Version 2.1 Software

Addendum to the IQ plus 510 and 710 Installation Manuals

Figure 1. Partial IQ plus 710 Version 2.1 CONFIG Menu, showing location of SMPRAT Parameter

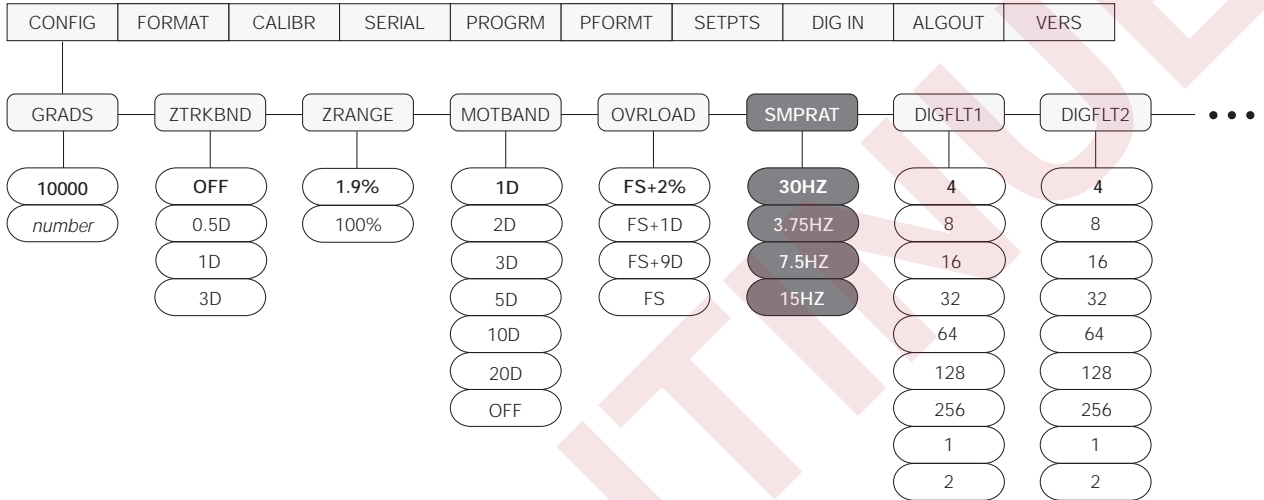
- SMPRAT parameter added to the CONFIG menu to allow selection of A/D sample rate in samples per second (see Figure 1). Lower sample rate values provide greater signal noise immunity.
- YYMMDD date format added to the DATEFMT parameter on the PROGRAM menus (see Figure 2).
